## CHRYSLER A604

### NEW PRNODL AND NEUTRAL SAFETY SWITCHES

Figure 17

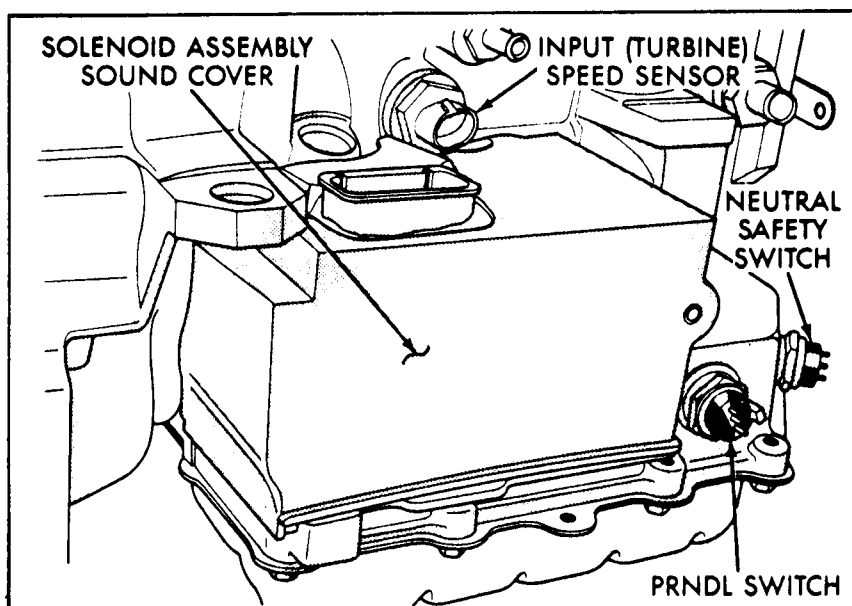
**CHANGE:** PRNODL Switch and Neutral Safety Switch have been changed for the 1990 model year, as well as the vehicle wiring harness connectors. Refer to Figure 17 for location of switches on the transaxle.

**REASON:** Positive locking mechanism, with a weathertight seal, to prevent the connection from becoming loose.

Figure 16

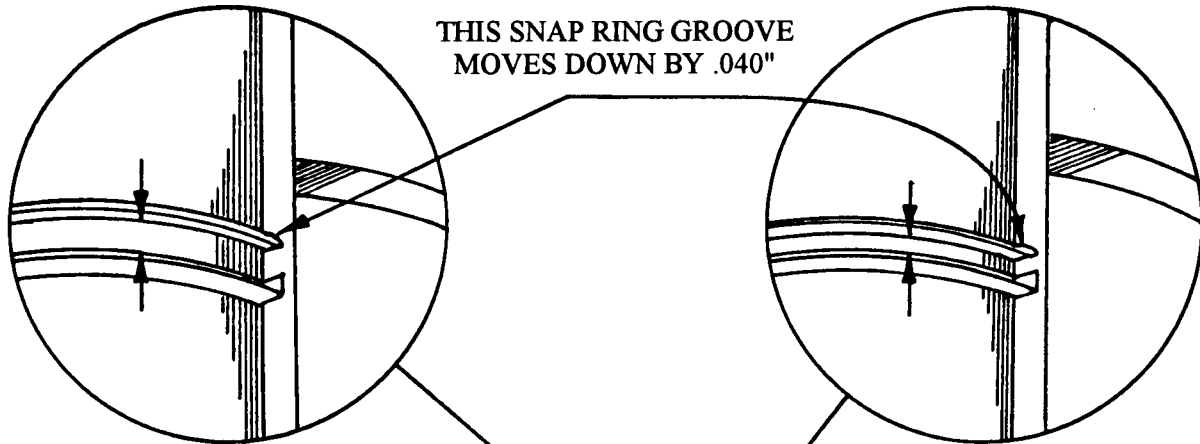
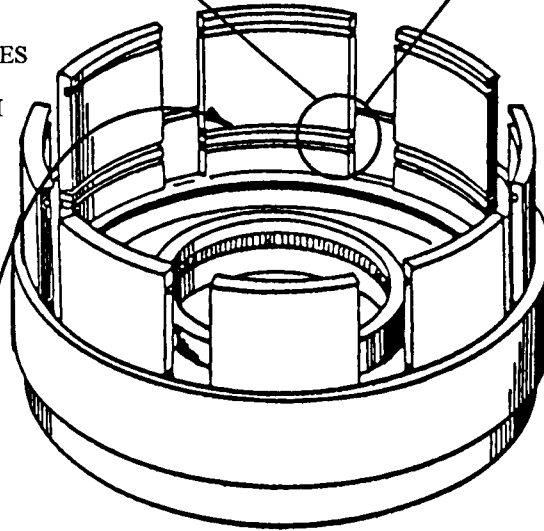
THIS SNAP RING GROOVE  
MOVES DOWN BY .040"

.123" OF DRUM MATERIAL  
BETWEEN THE SNAP RING GROOVES  
MEANS THAT THIS IS A 3 OD  
FRICTION INPUT CLUTCH DRUM

.083" OF DRUM MATERIAL  
BETWEEN THE SNAP RING GROOVES  
MEANS THAT THIS IS A 4 OD  
FRICTION INPUT CLUTCH DRUM

THE UPPER SNAP RING GROOVE WAS MOVED DOWN .040" AS A PART OF A  
DIMENSIONAL CHANGE TO ACCOMMODATE THE EXTRA STEEL AND LINED PLATE

1989 INPUT CLUTCH RETAINER.....	4431609
1990 INPUT CLUTCH RETAINER.....	4505623
